# **Verification Report**

## Aurora Energy CPP Application

8 June 2020

Figure 1.2 – Aurora Energy changes to expenditure forecasts

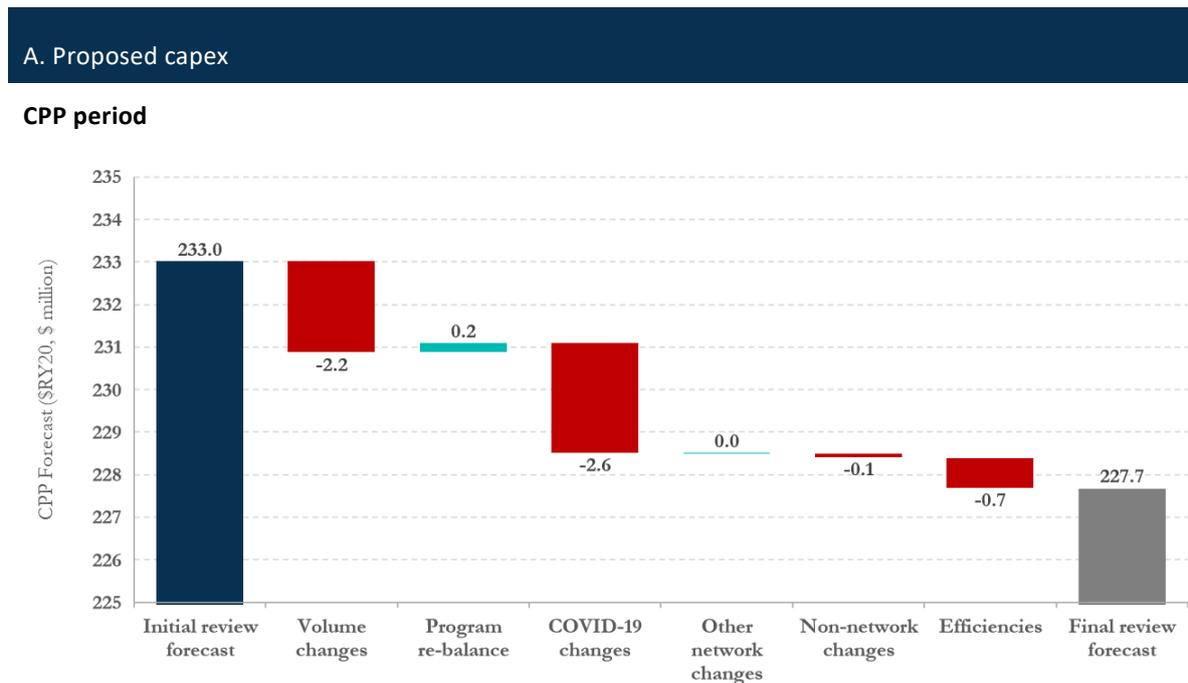
In aggregate, and in response to our draft verification findings, Aurora Energy reduced its capex forecasts by \$5.3 million (a 2.3% reduction) and increased its opex by \$2.1 million (a 1.4% increase) over the CPP period, or a \$12.4 million reduction and \$1.4 million increase over the review period respectively (see Figure 1.2).

Figure 3.1 – Planned SAIDI and SAIFI

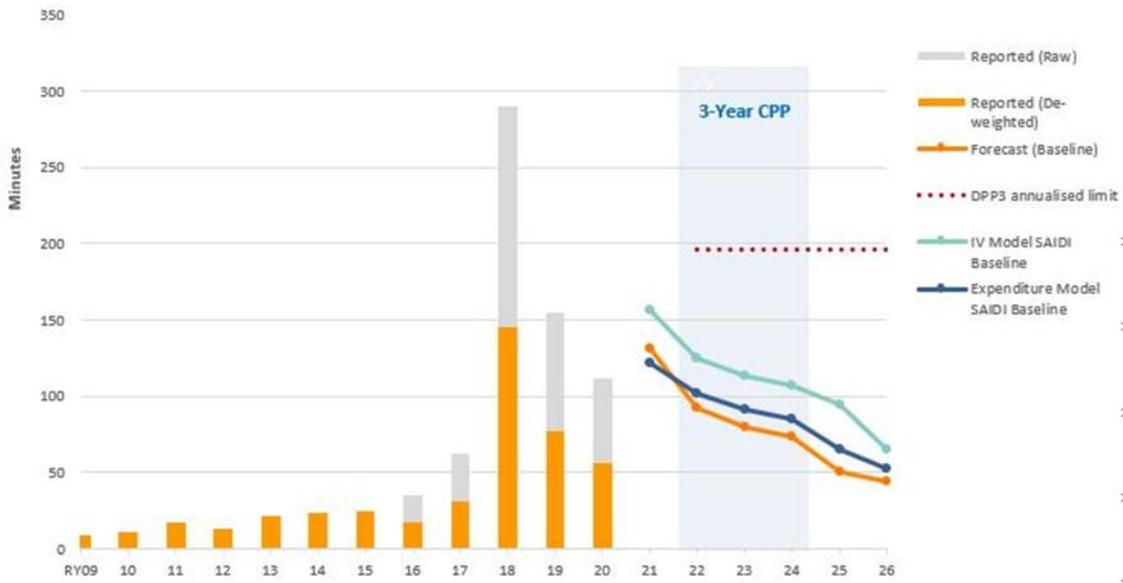
The method and approaches used are generally not unreasonable. However, as discussed further in Appendix E and section 3.2.3, the forecasting approaches for planned SAIDI and SAIFI, as applied, both appear to understate forecasts, particularly planned SAIFI. Our adjusted baseline targets, based on this review, have been overlayed in Figure 3.1.

Aurora Energy provided a further revised model (v5.05) with an explanatory note with limited available time for us to fully review these changes. We were still not convinced that Aurora has adequately addressed these concerns and our view is that the model still understates the forecasts for planned reliability over the CPP period. This is further discussed in the findings in section E.5.6.

Figure 3.2 – Unplanned SAIDI and SAIFI

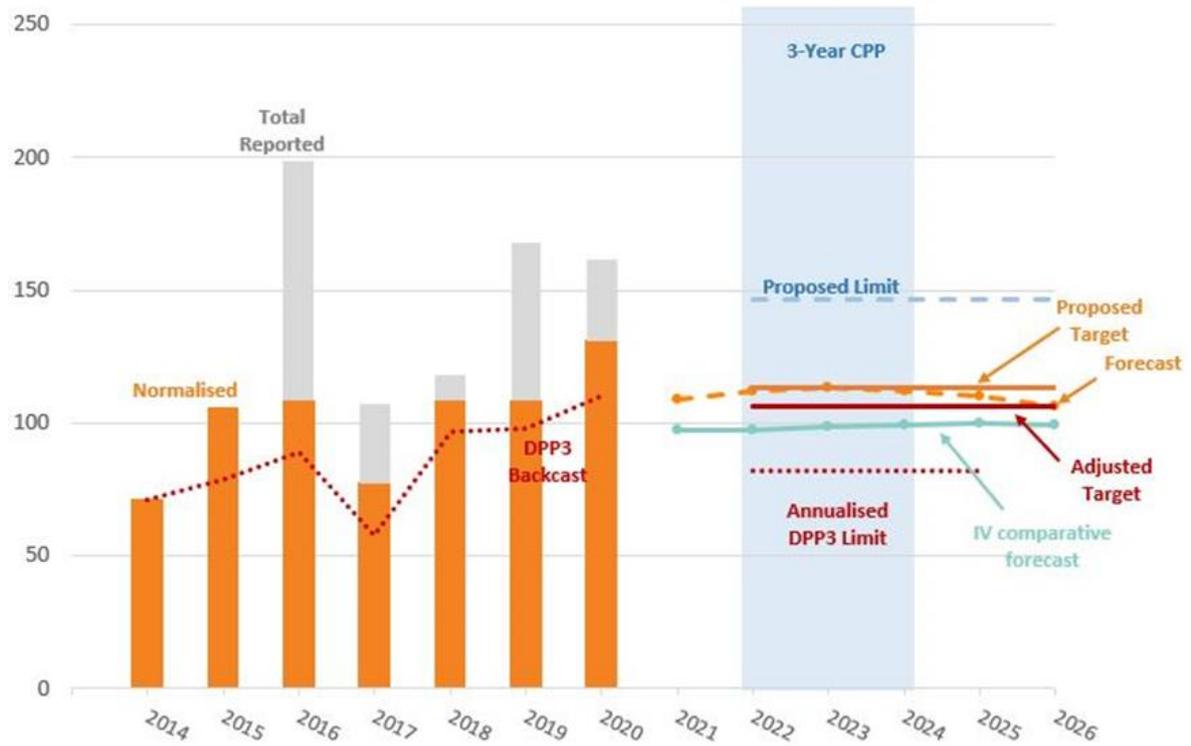
We discuss our concerns in detail in Appendix E and further with respect to the findings in section 3.2.3. Our adjusted targets, based on this review, have been overlayed in Figure 3.2.

**Figure C.28: 2019 Reactive Maintenance expenditure per circuit km vs customer density (selective EDBs, \$2020, \$000)**

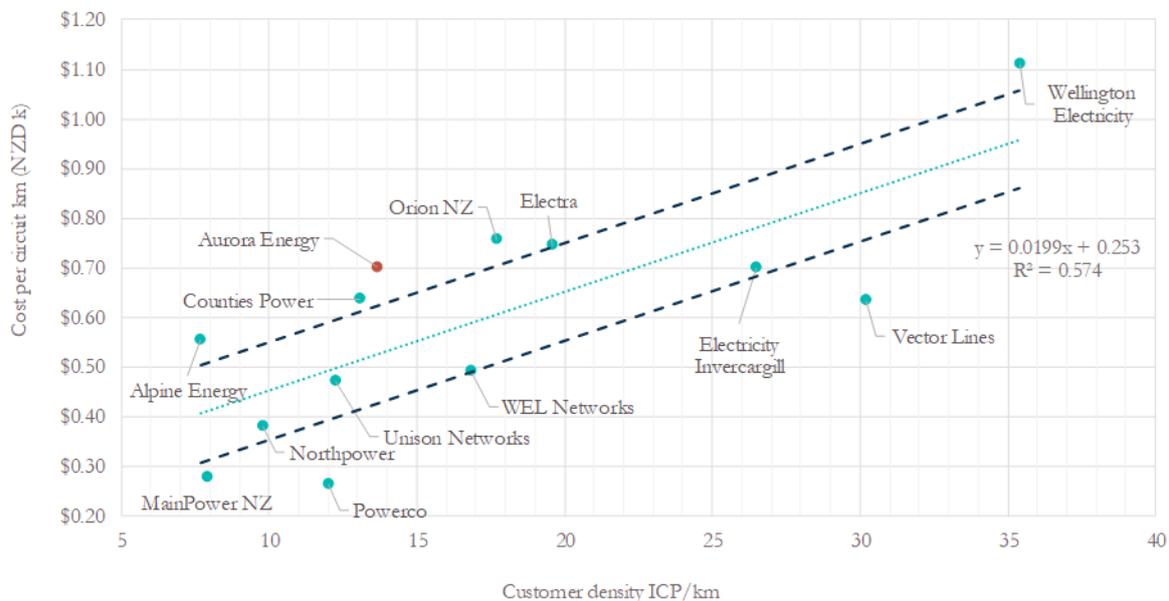
Figure C.28 shows that Aurora Energy’s reactive maintenance per circuit kilometre benchmarks well above the confidence interval, which perhaps is unsurprising giving the poor condition of many asset fleets and that Aurora Energy’s network is split between two distinct geographical locations with areas of remote access. However, it may also be explained by inefficiencies in base expenditure – which is somewhat confirmed by Aurora Energy itself proposing a negative step change for improved reactive maintenance practices and a positive step change to introduce a 24/7 dispatch service to improve response times.

However, in relation to the nominated comparable EDBs, Aurora Energy benchmarks well for reactive maintenance costs per failure rate per 100 kilometres, as shown in Figure C.29. This indicates that the field service provider was relatively efficient compared with the selected EDBs with regards to fault rectification time.

Figure C.31: RY15–RY19 vegetation management per overhead circuit km vs overhead circuit length (\$000, \$2020)

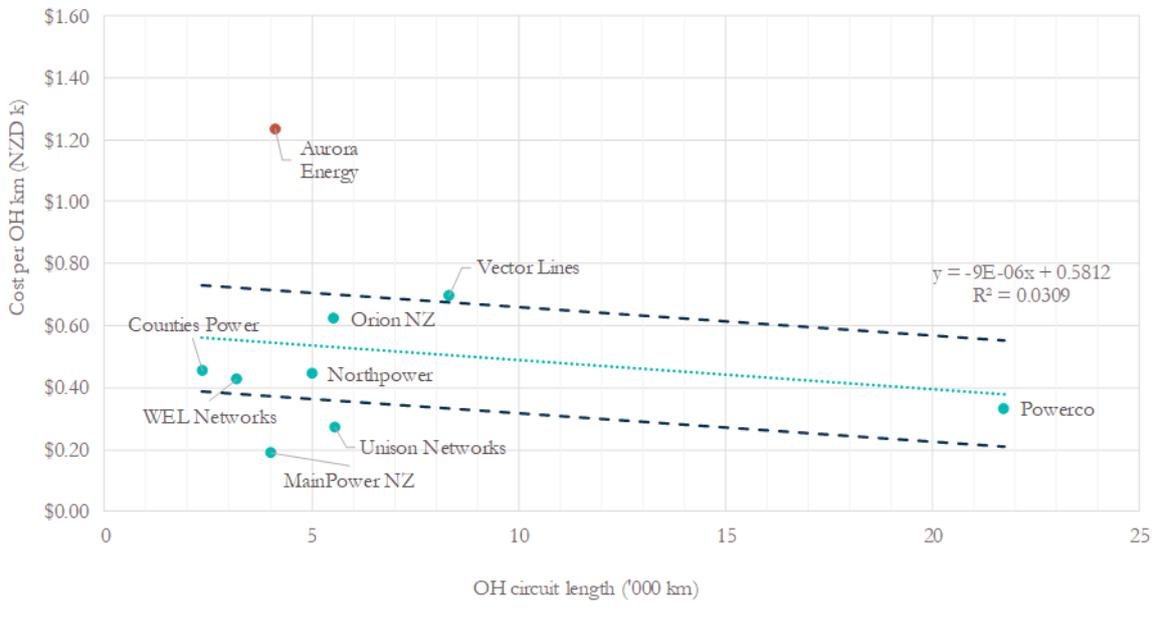
As an illustration, Figure C.31 compares Aurora Energy’s vegetation costs per overhead circuit kilometre with selected EDB peers for the five-year period RY15–19, but only as an indication as to the efficiency or otherwise of the Aurora Energy costs.<sup>218</sup> Overhead circuit length was used to normalise results. The chart retains the same comparator EDBs as that used above for maintenance and indicates that Aurora Energy’s vegetation management costs appear noticeably high than that for other EDBs – about 56% above the trend line and 42% above the upper confidence bound.<sup>219</sup>

Figure C.34: 2015–19 vegetation management per OH circuit km vs OH circuit length (AU\$million, \$2020)

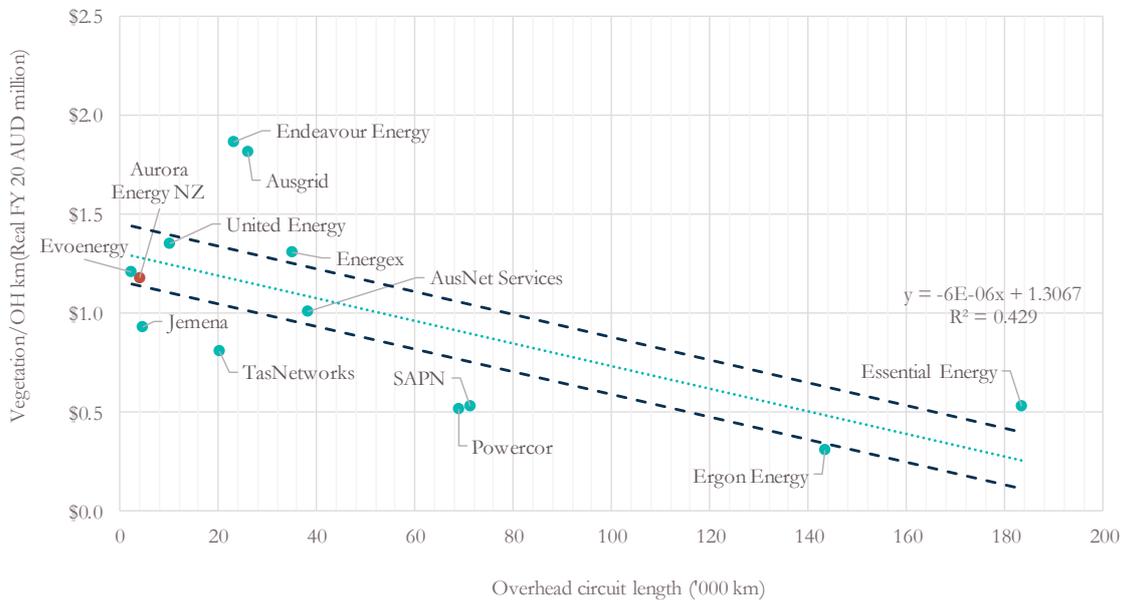
Given these challenges, we also compared Aurora Energy’s vegetation costs against those of Australian EDBs using RIN data published by the AER. As shown in Figure C.34,<sup>222</sup> this comparison suggests that Aurora Energy’s vegetation costs *are* consistent with that of Australian EDBs – somewhat in contrast to that of the New Zealand benchmarking. Although care should be taken when interpreting these results in particular,<sup>223</sup> the chart suggests that the New Zealand comparison may be affected by factors not readily adjusted for using the data available. For instance,

- in considering total circuit length, the ratio of overhead to underground is important – for that reason, our indicative Australian EDB comparison has excluded CitiPower, as this is an urban distributor in Melbourne with a high proportion of underground
- together with the overhead to underground ratio, the nature of the EDB – as shown in Figure C.34, EDBs below the trendline are generally rural, while those above are urban, suggesting that additional factors such as traffic control may influence cost comparisons.

Figure D.7: Power transformer replacements over the review period (Aurora Energy data mapping)

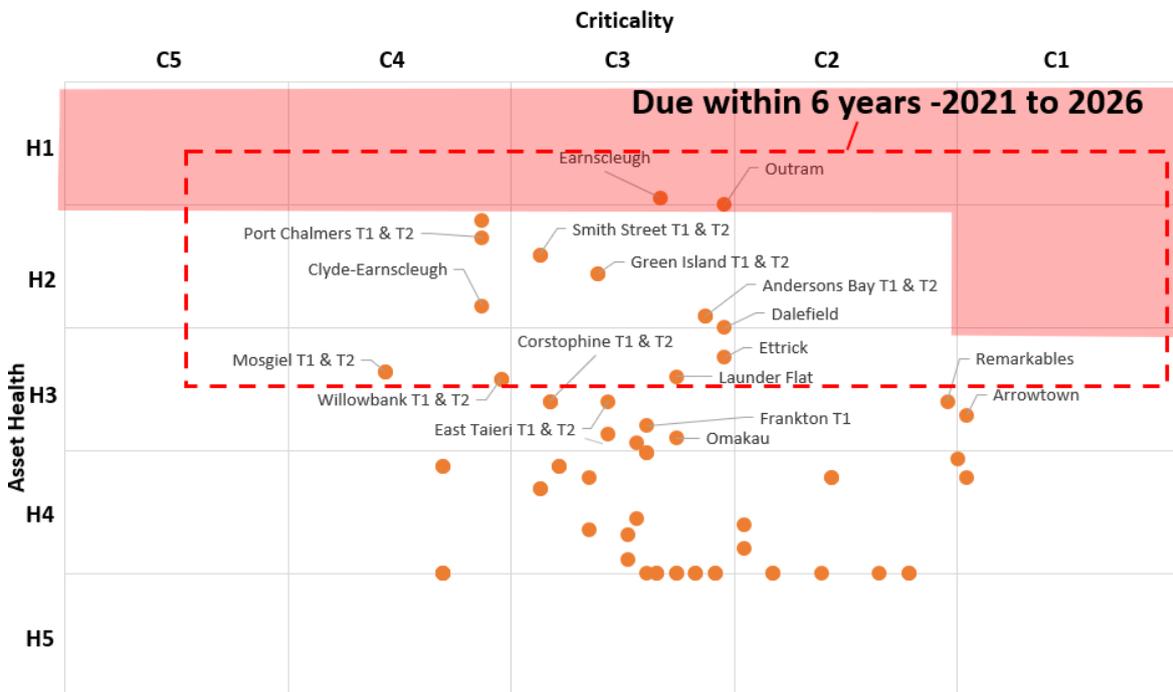
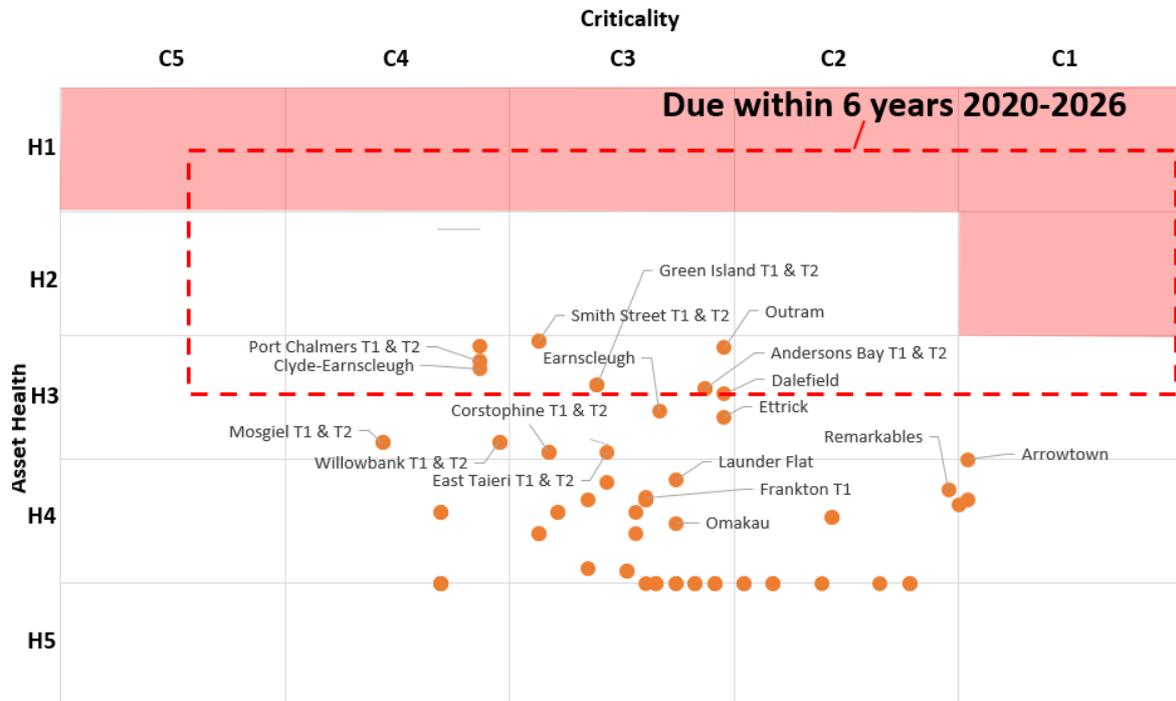
After we made changes in the model, Figure D.7 and Figure D.8 below demonstrate the difference in forecast transformer replacement over the review period.
